RE: **Blythe Solar Power Project, Docket No. 09-AFC-6**
Responses to January 14, 2010 CEC Workshop Queries
Technical Areas:
Soil & Water Resources (supplemental data for DR-S&W-218)

**Soil and Water Resources
(Supplemental Data for DR-S&W-218)**

Blythe Solar Power Project
Docket No. 09-AFC-6

Soil and Water Data Responses to January 14, 2010 CEC Workshop Queries

- PRELIMINARY -
NOT FOR CONSTRUCTION

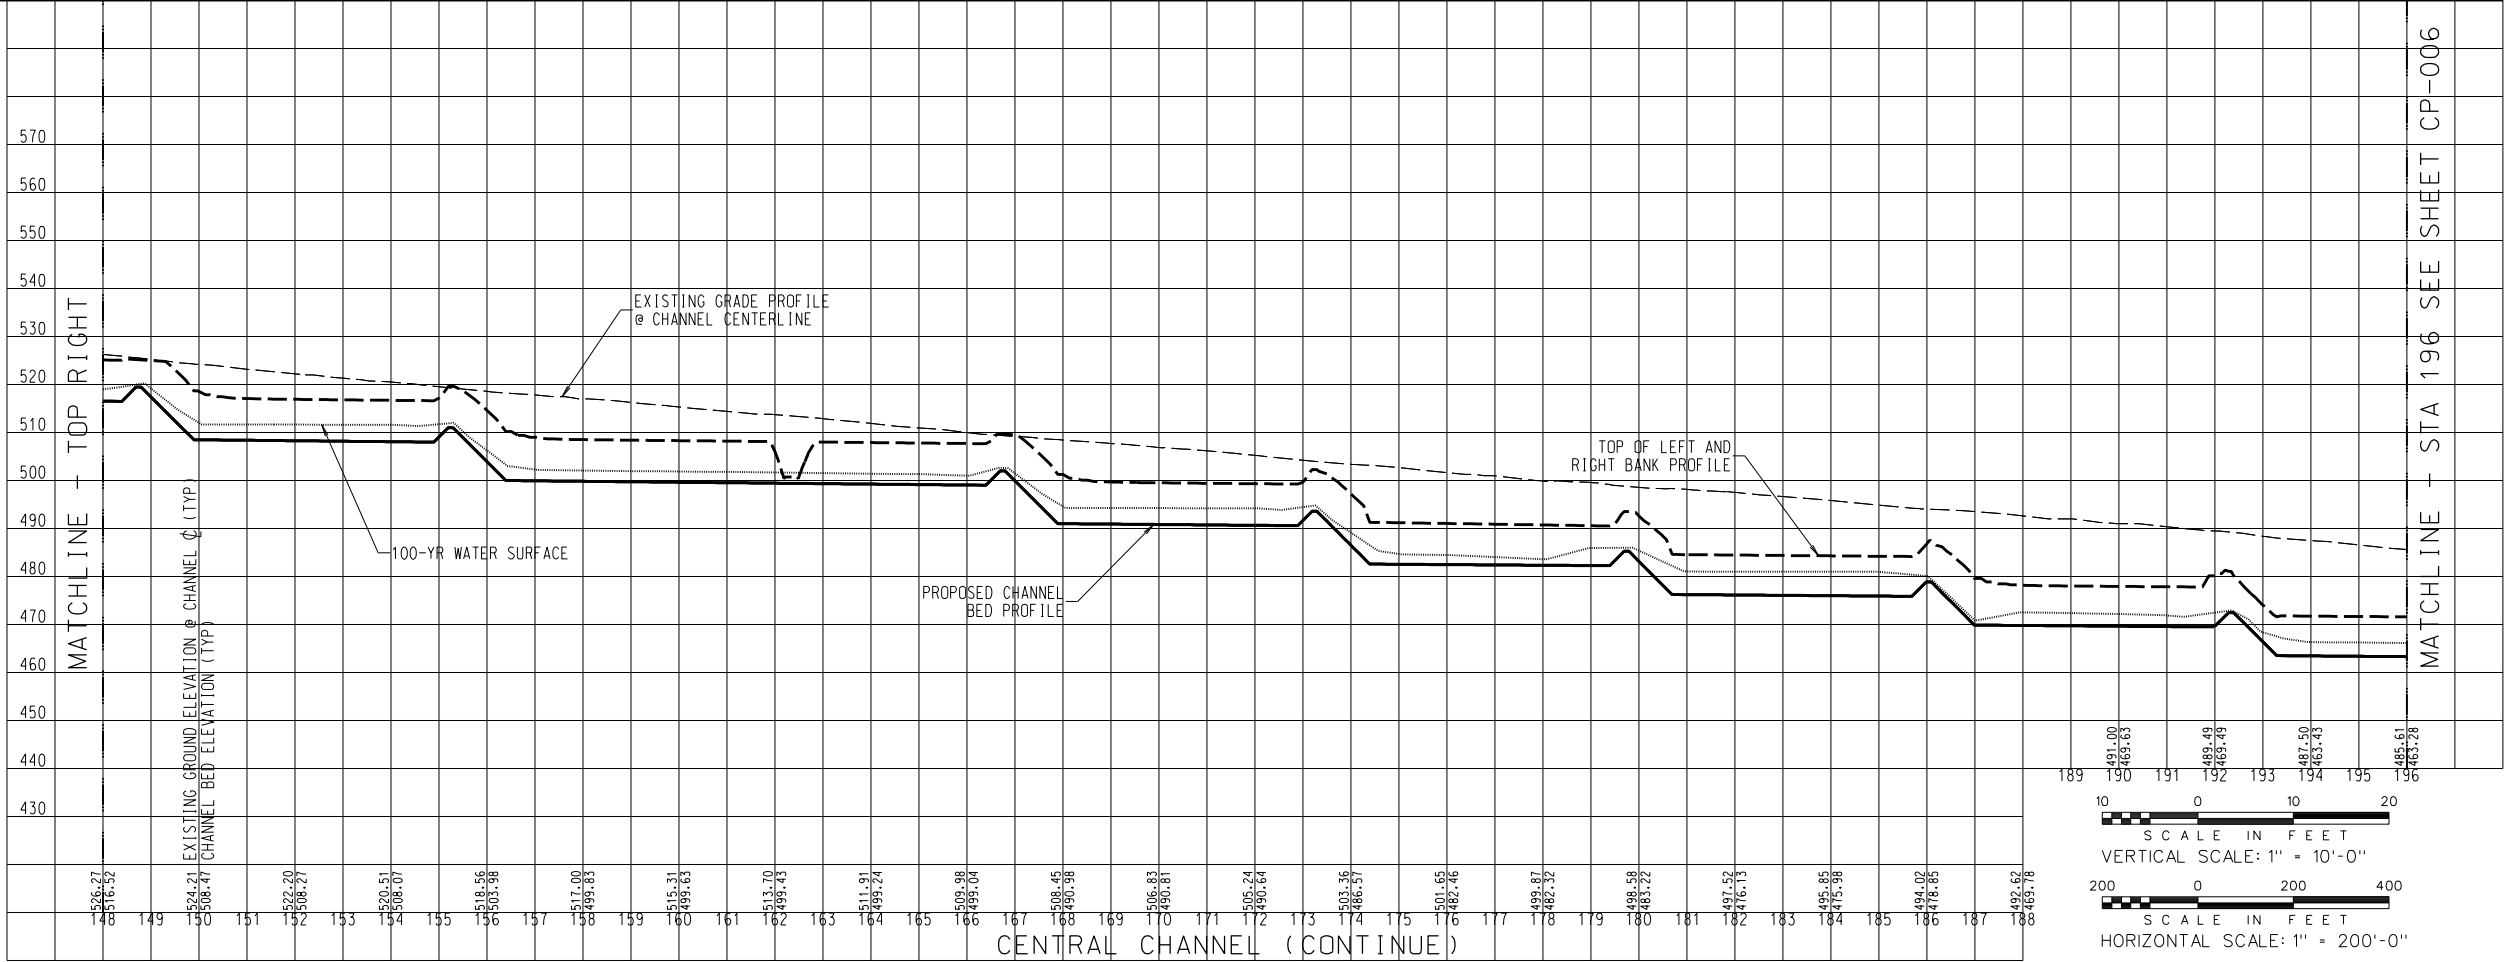
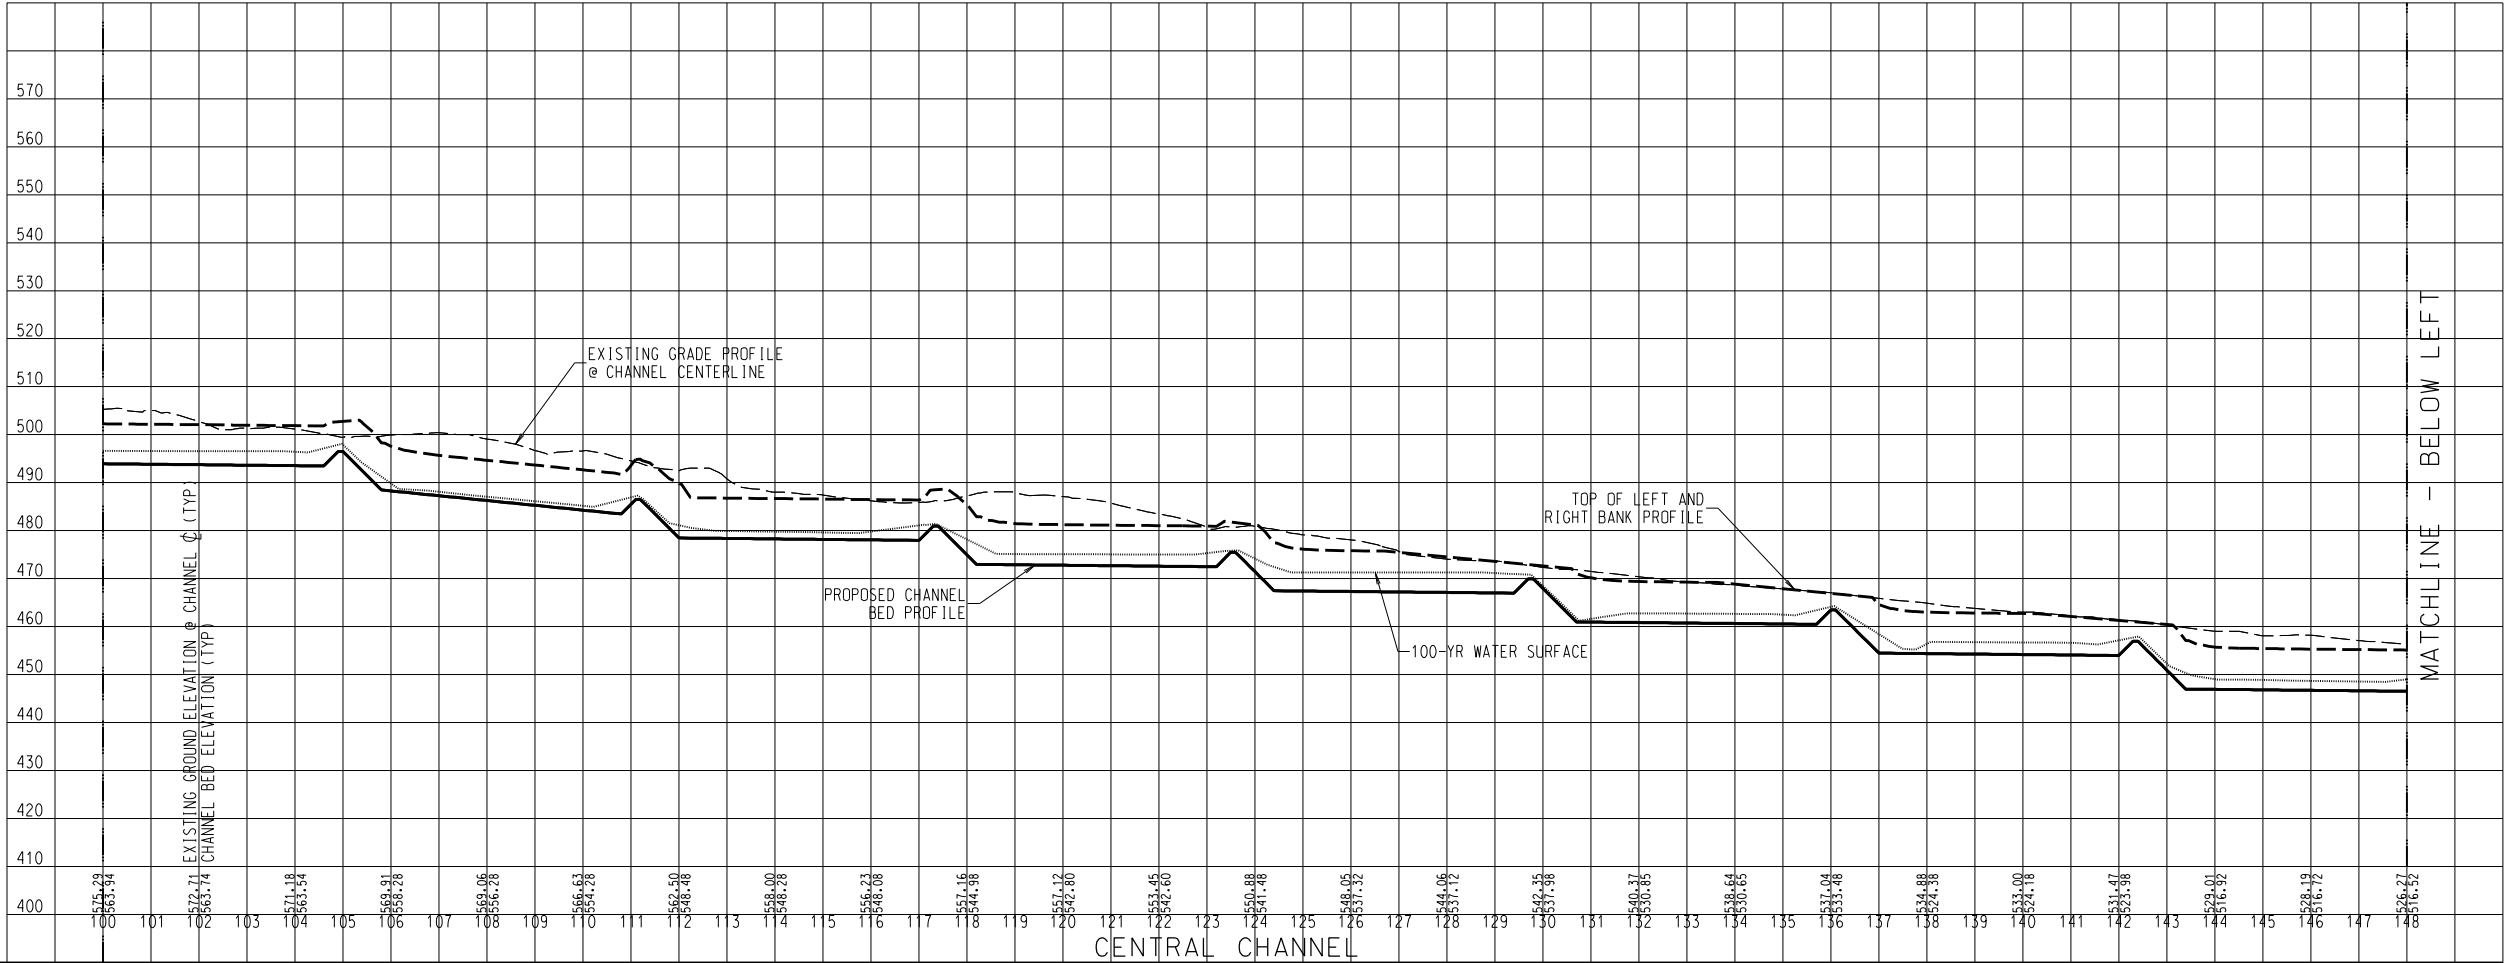
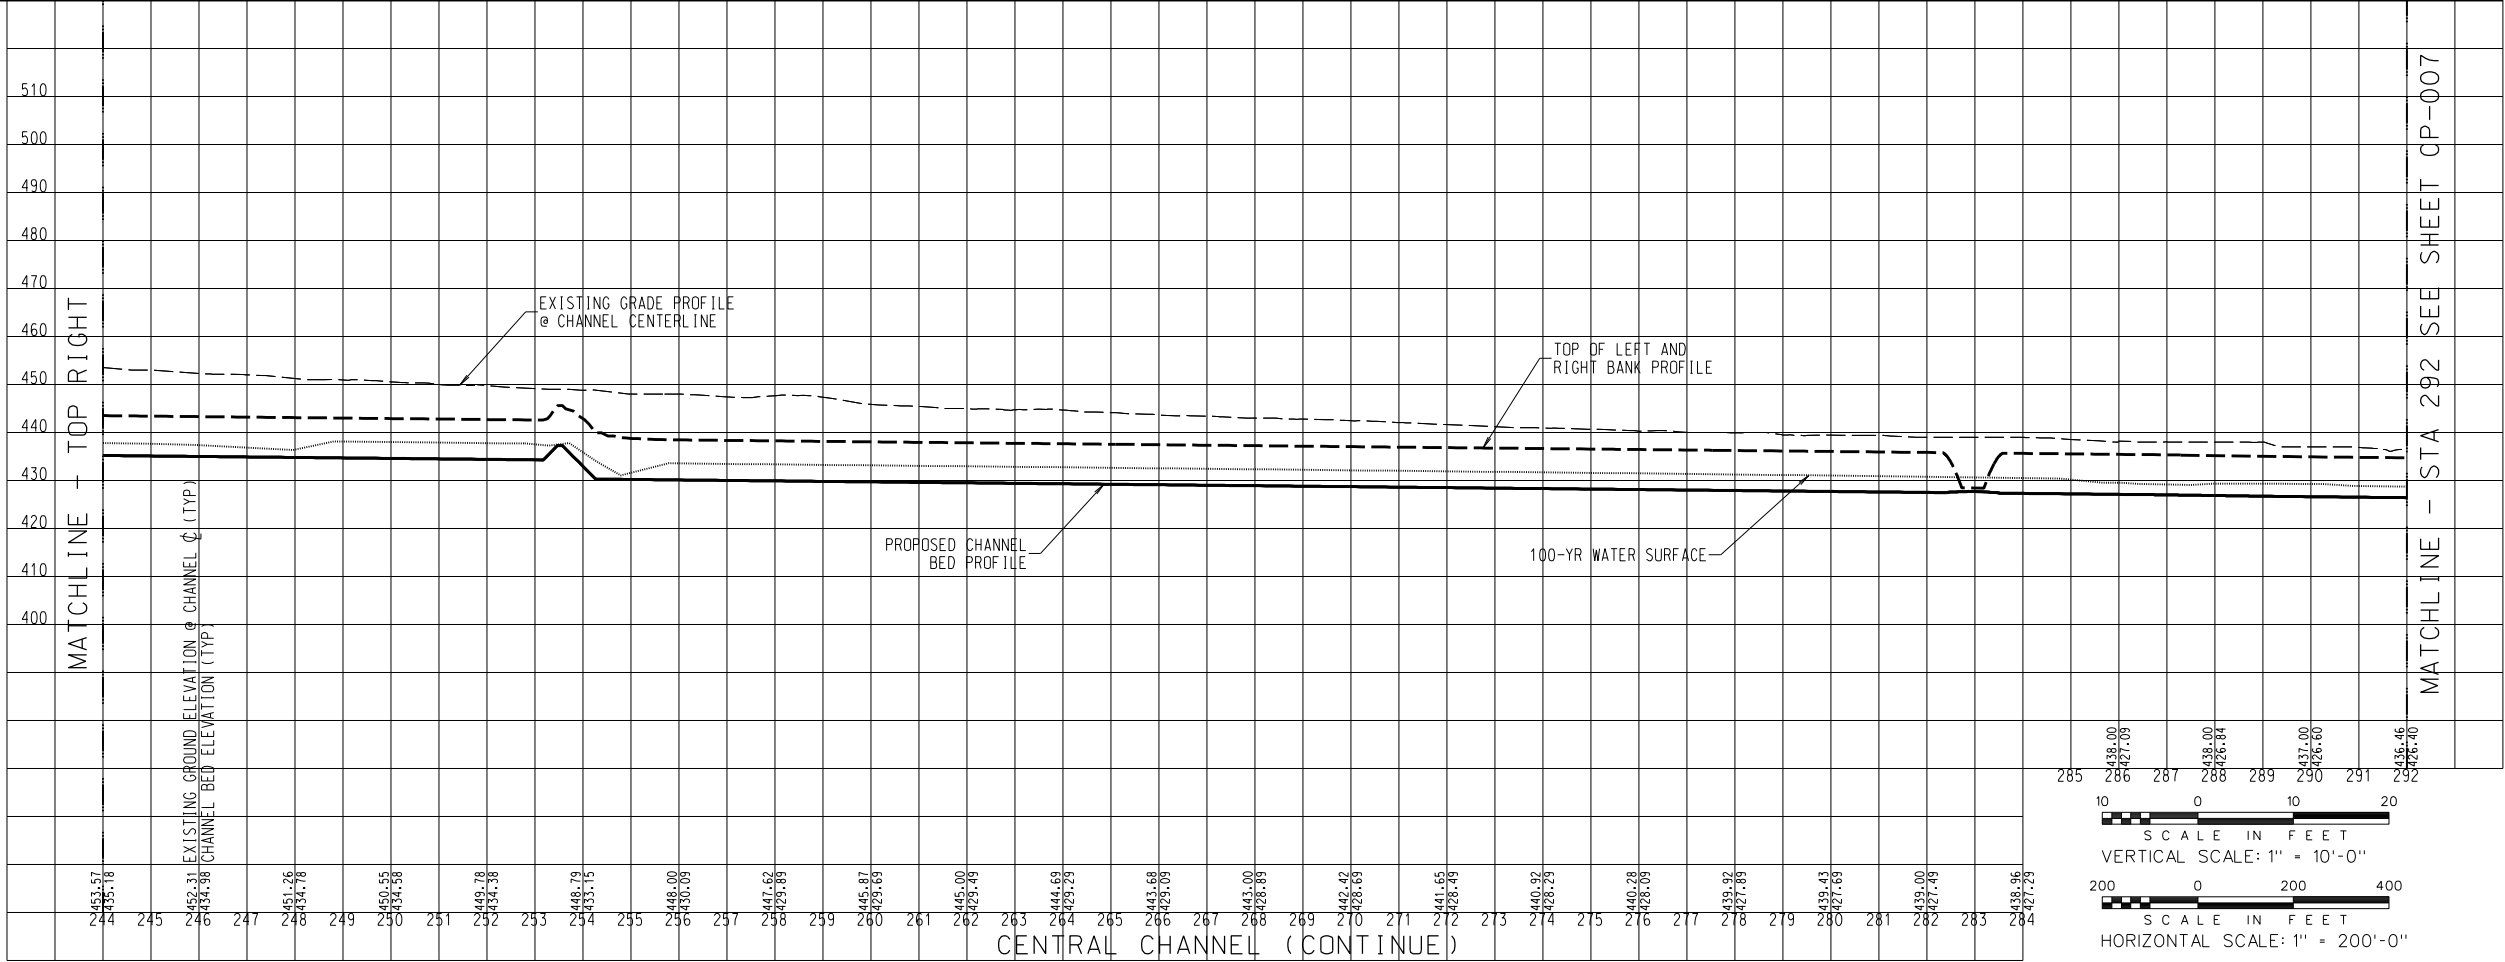
Add 100-yr. water surface elevations on profiles for main channels (both collectors and conveyance).

The 100-year water surface profile has been added to the plans and is provided on Sheets CP-001 to CP-009 as part of this response.
